Planning and Zoning Commission

December 03, 2019

TO: Planning and Zoning Commission
FROM: Alex Pfaltzgraff, Development Services Director
DATE: December 3, 2019
RE: Legacy Park Lot 1 – Site Plan

RE: Legacy Park Lot 1 Site Plan

REFERENCE NUMBER:
DRAWN BY: BK & CJ
CHECKED BY: CJB
REVISION DATE: 10/10/19 CITY #1 11/11/19 CITY #2 11/25/19 CITY #3
PROJECT NUMBER: 160387-1
SHEET NUMBER: C4.1

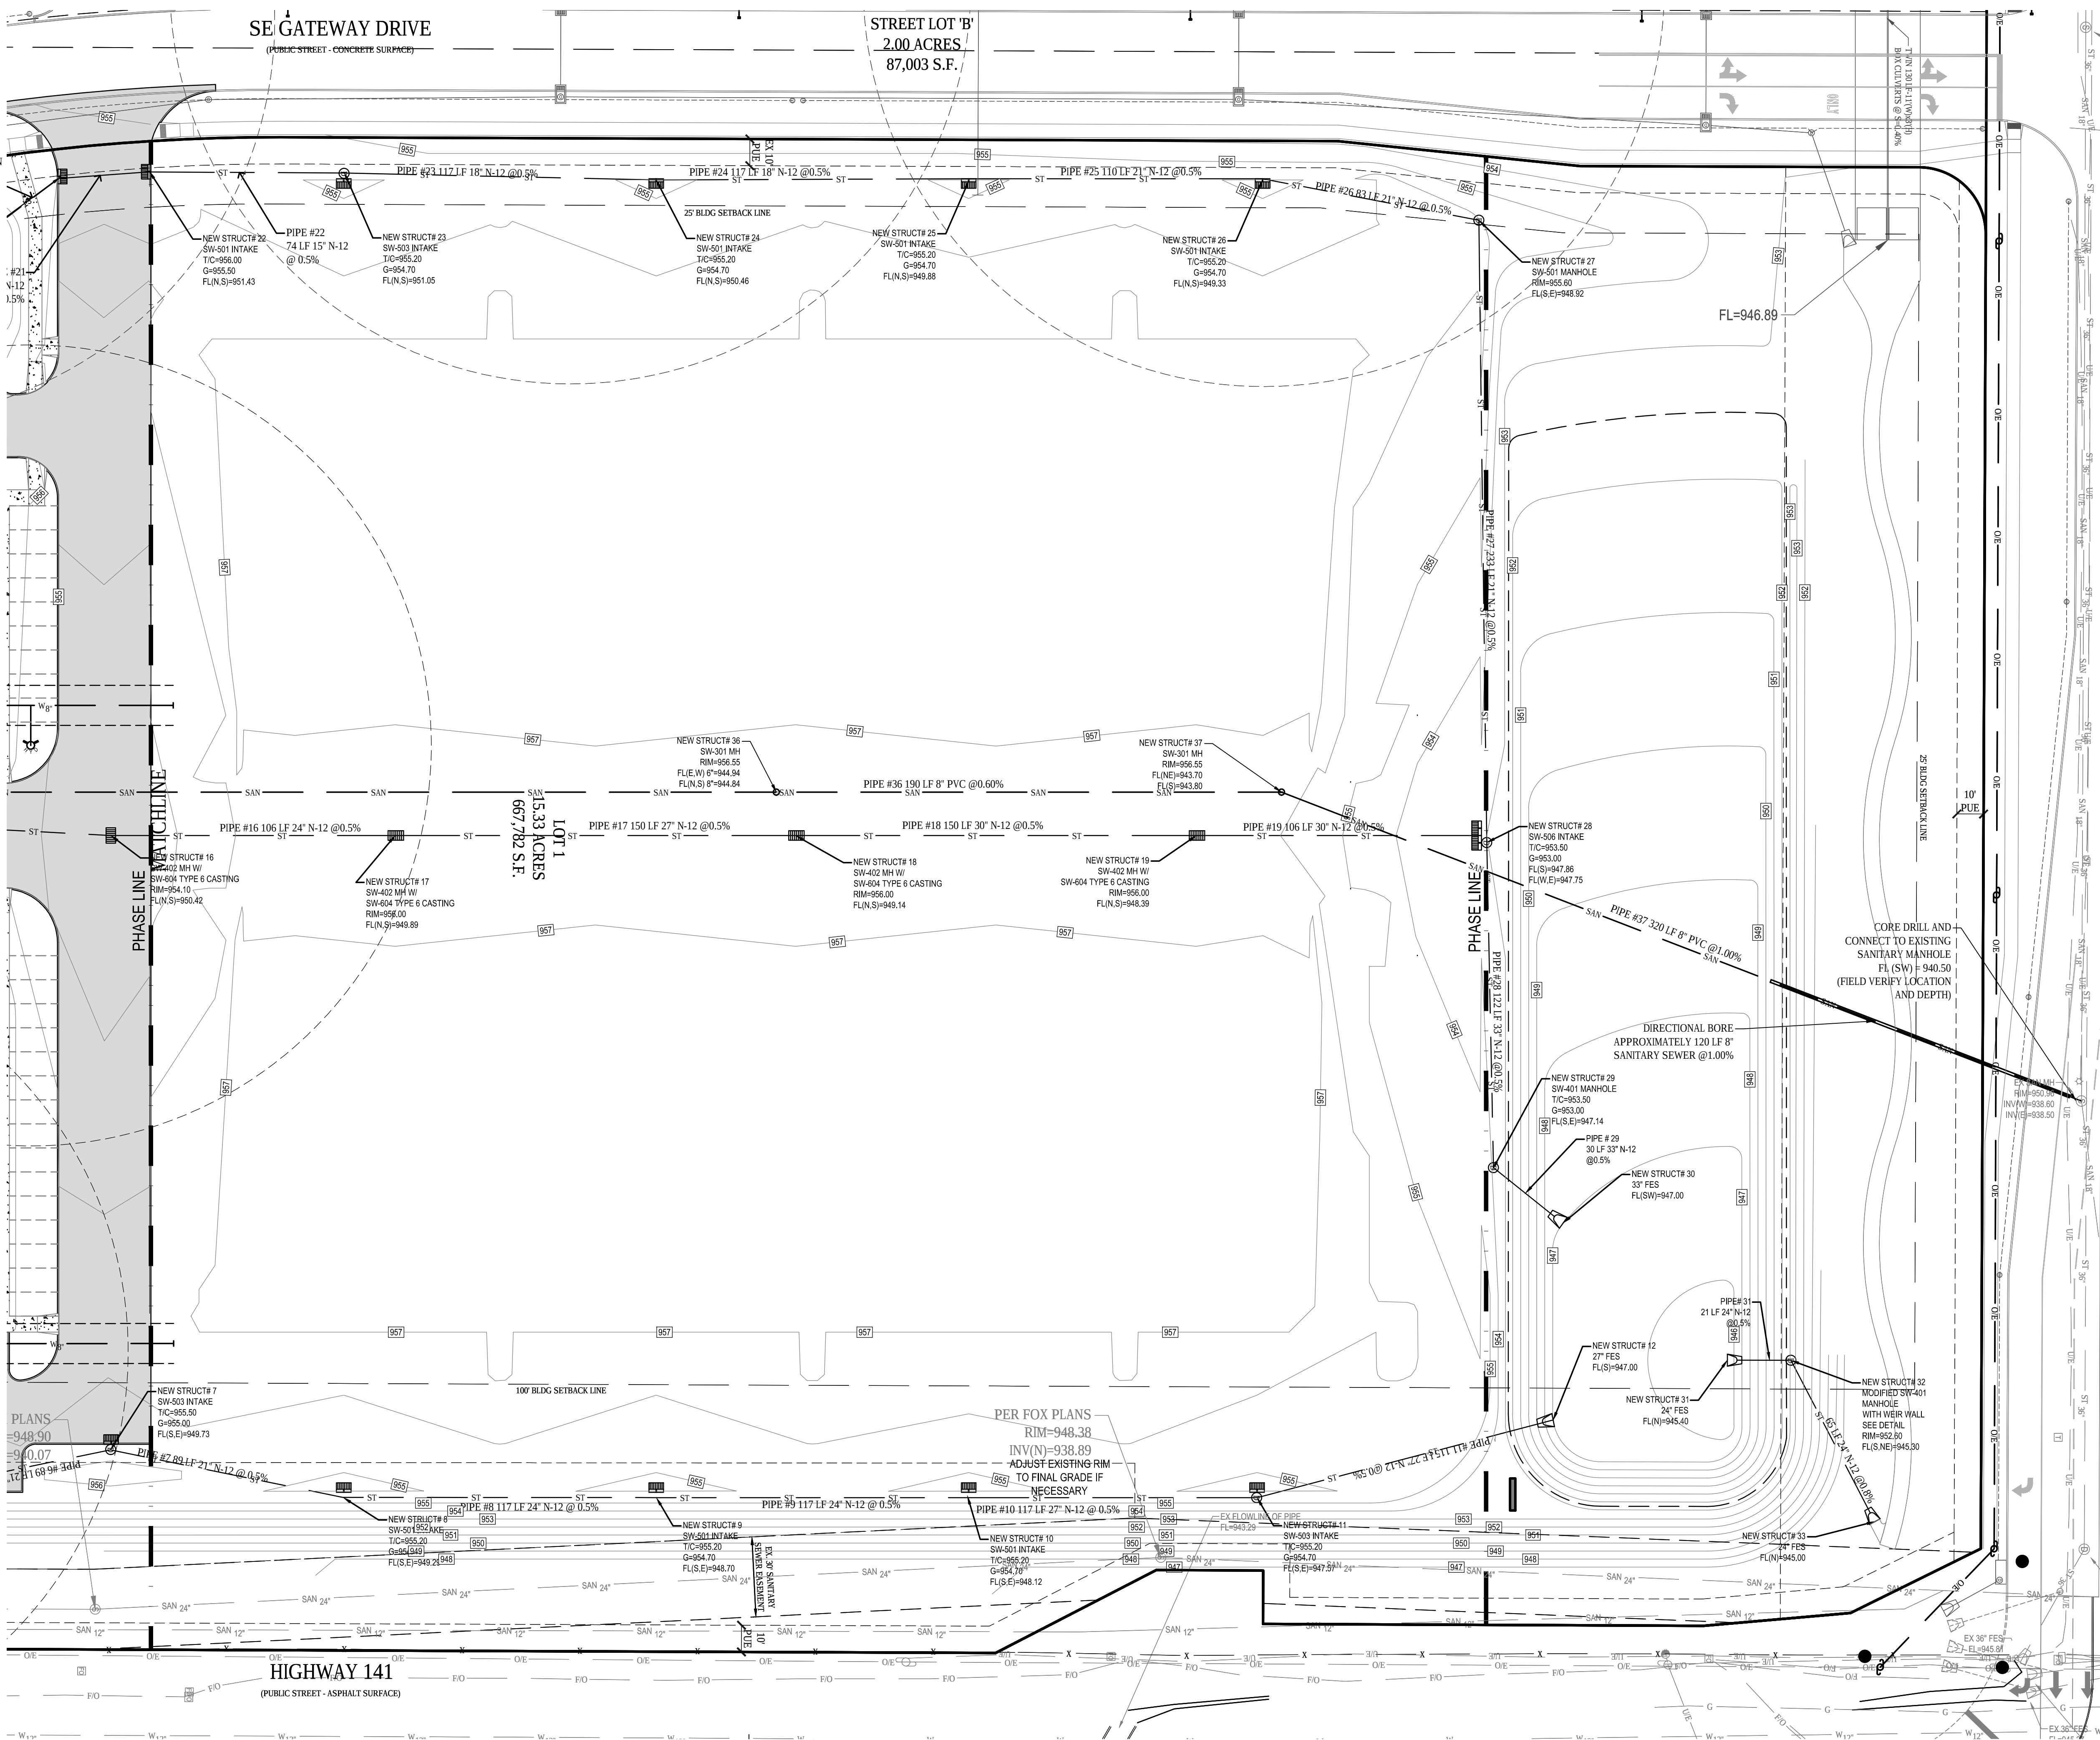
- ~~26. Staff questions if a rain guardian or similar would be better option than the scour stop mat for the two curb openings on the western basin.~~

- ~~29. Proposed plantings appear to be located in a manner that would impact the 5-foot clear space requirement for the hydrants within the parking islands. The FD would like to see the trees shifted 1-2 feet further south to allow for tree growth.~~

~~30. Please provide details for new storm structure #1. Please provide prior to P&Z~~

C5.2

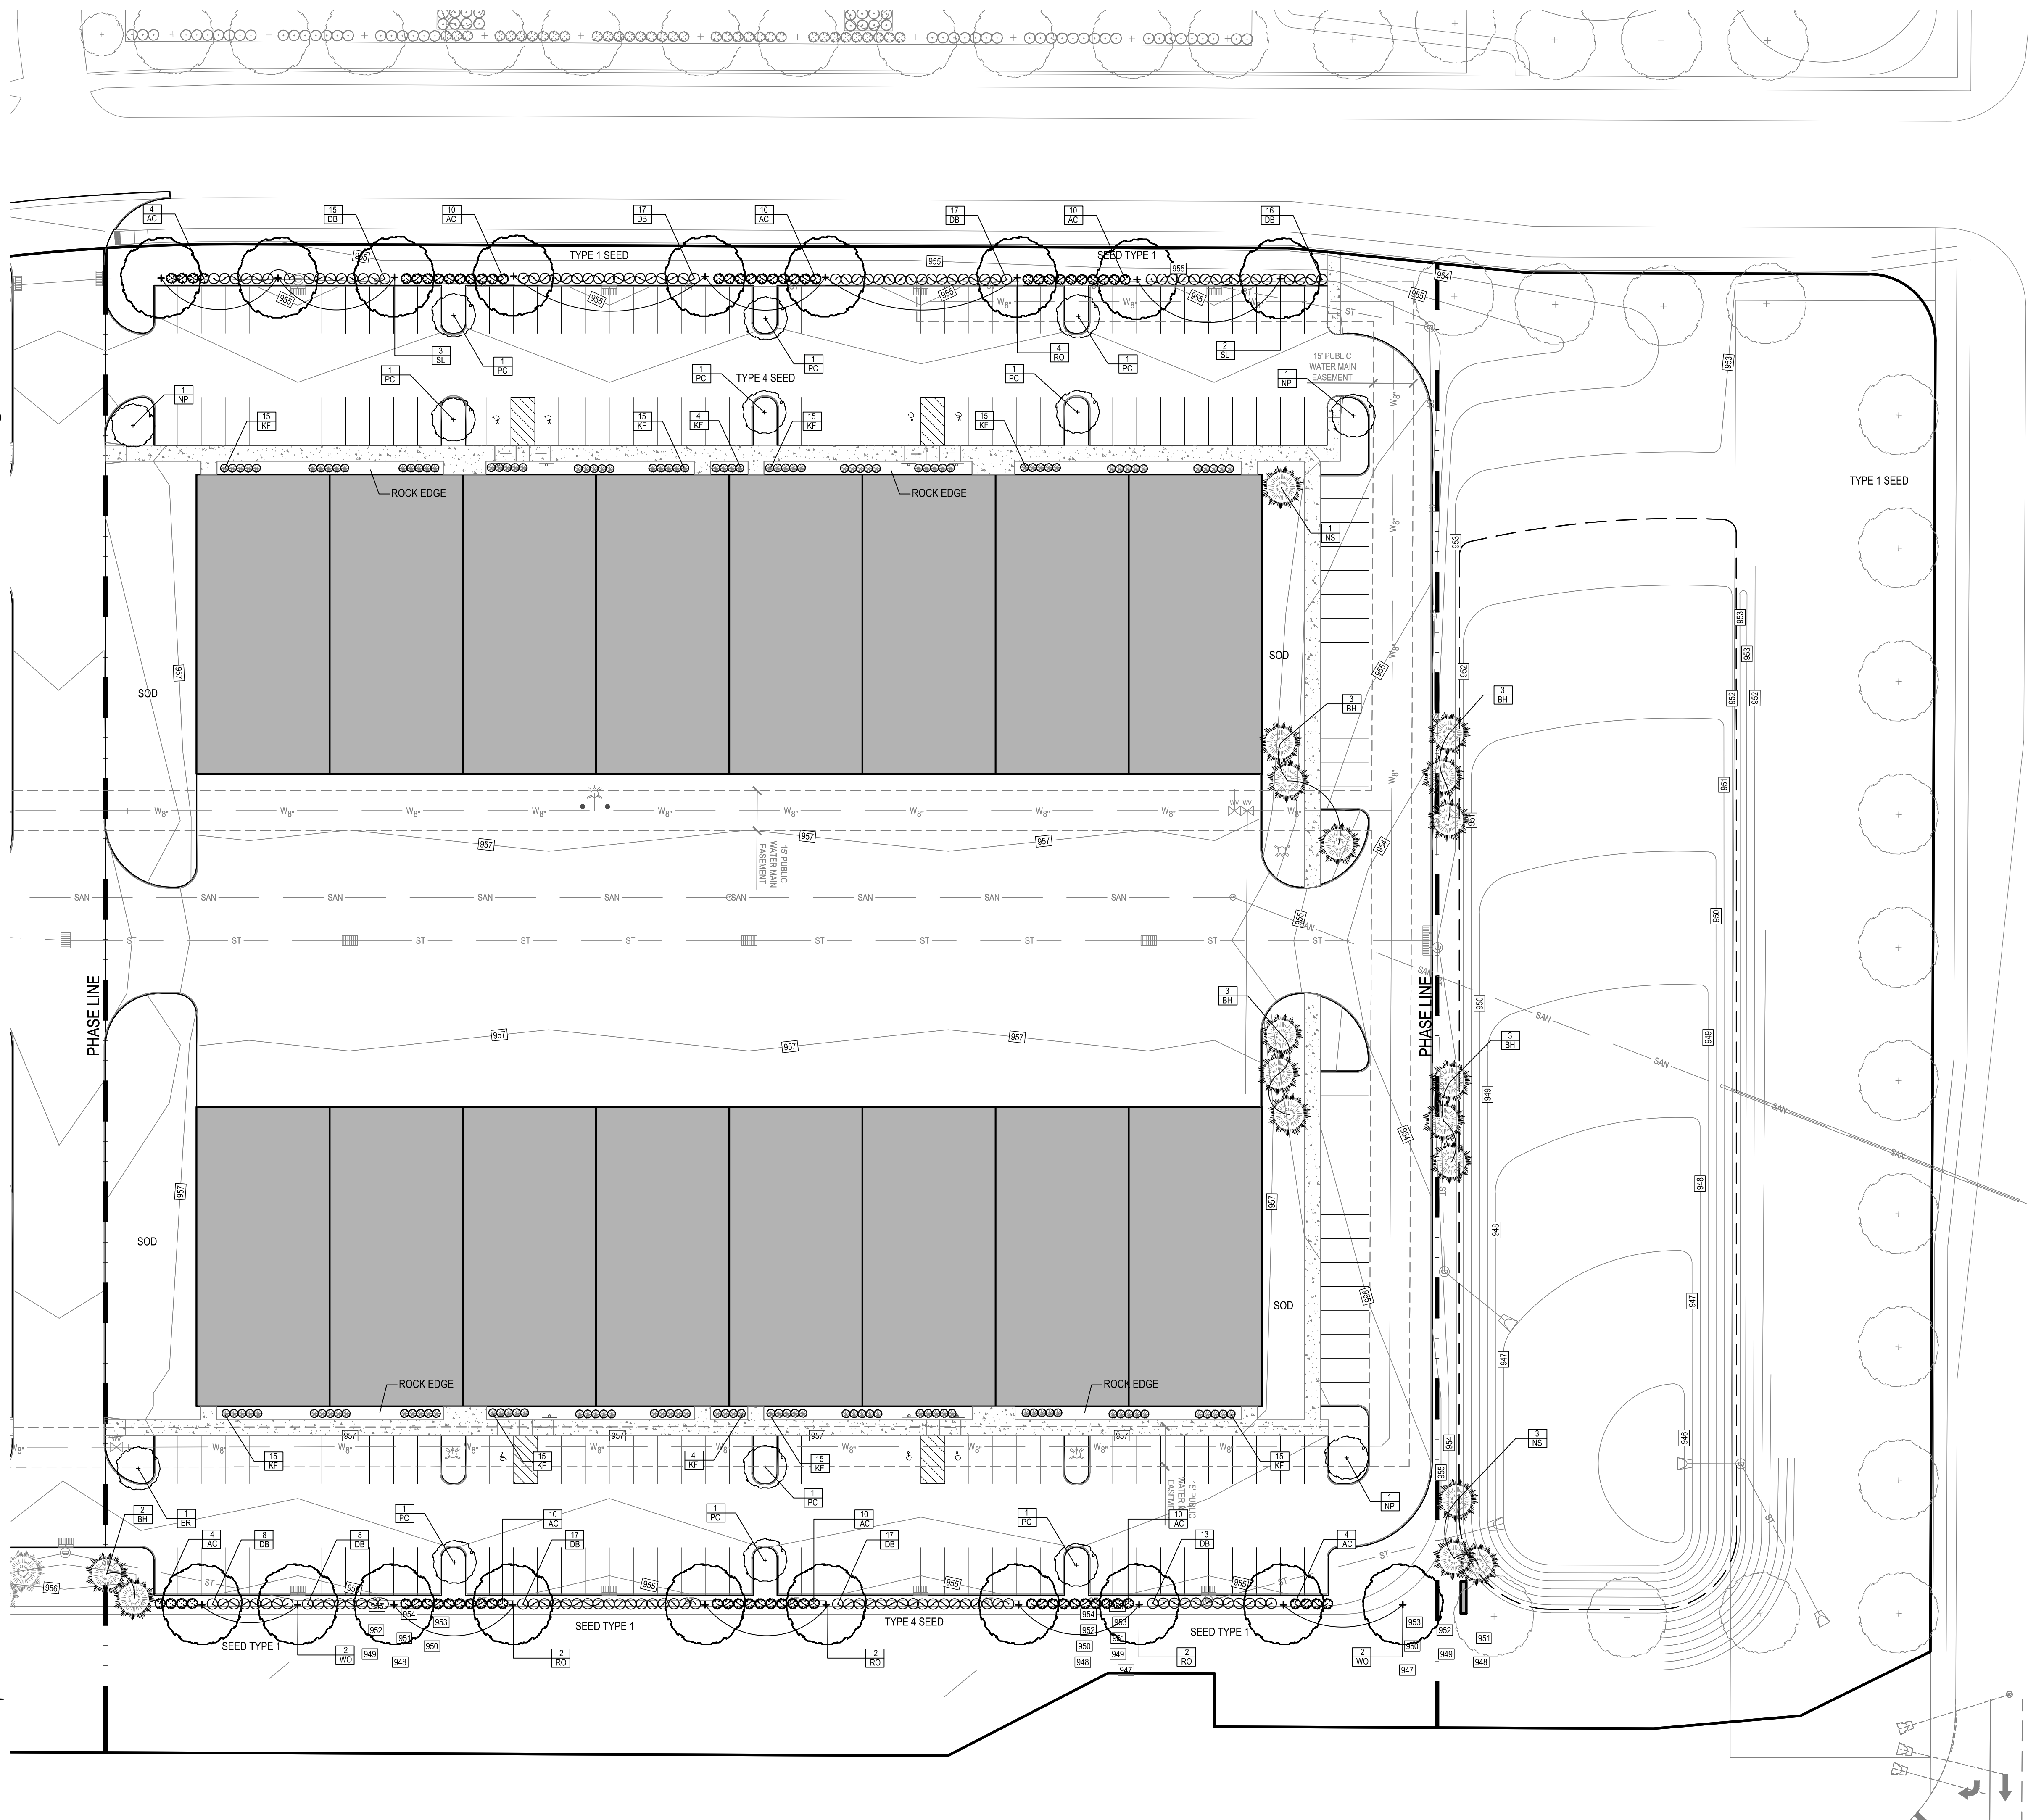
~~37. Please consider additional plants south of the basin, near the central portion, to provide additional screening to into the rear of the buildings.~~

SHEET NUMBER:
C7.4

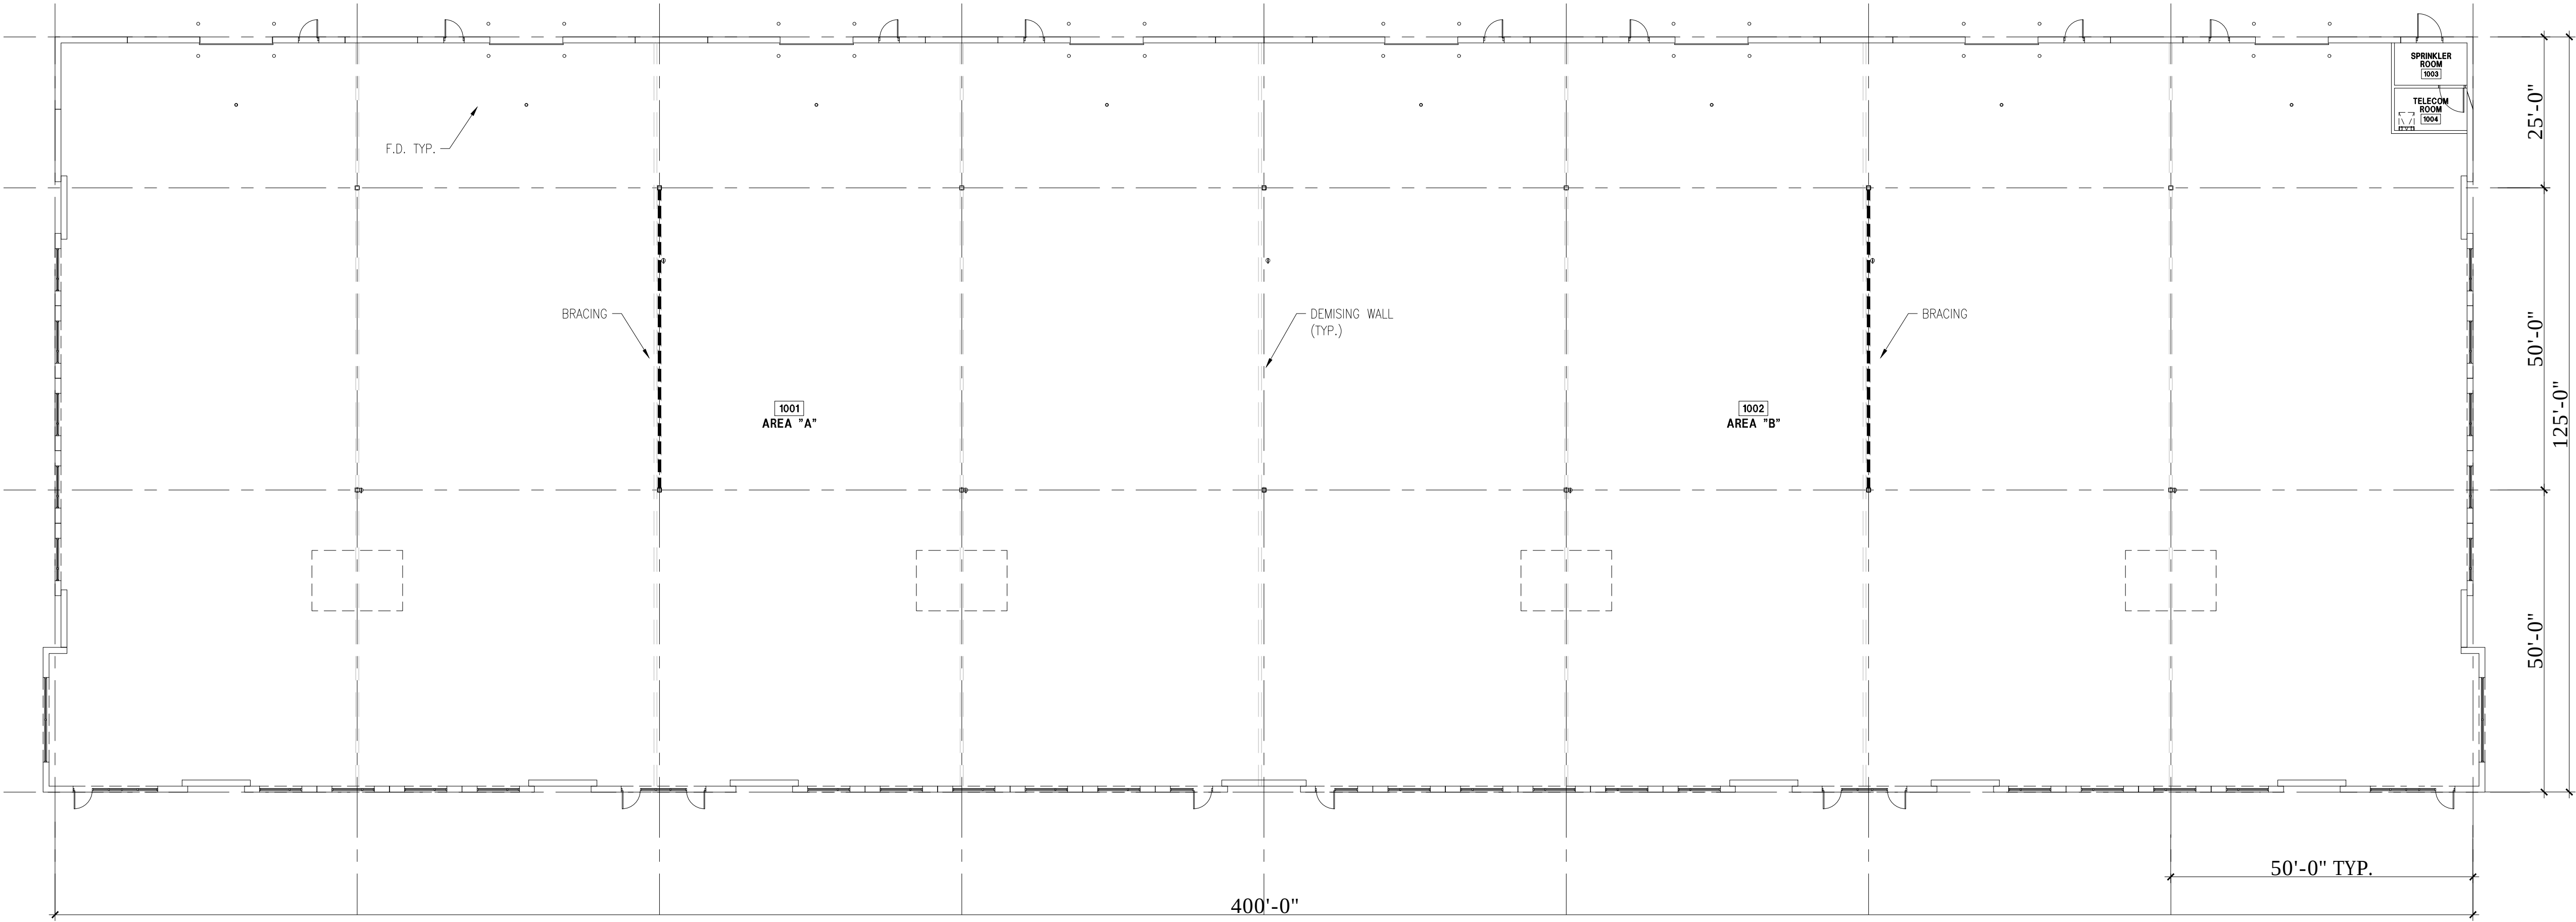
- ~~44. There is an area intake, in middle of sheet, future pavement, that needs control.~~
- ~~45. The detention basin should have a temporary detention structure, need details.~~
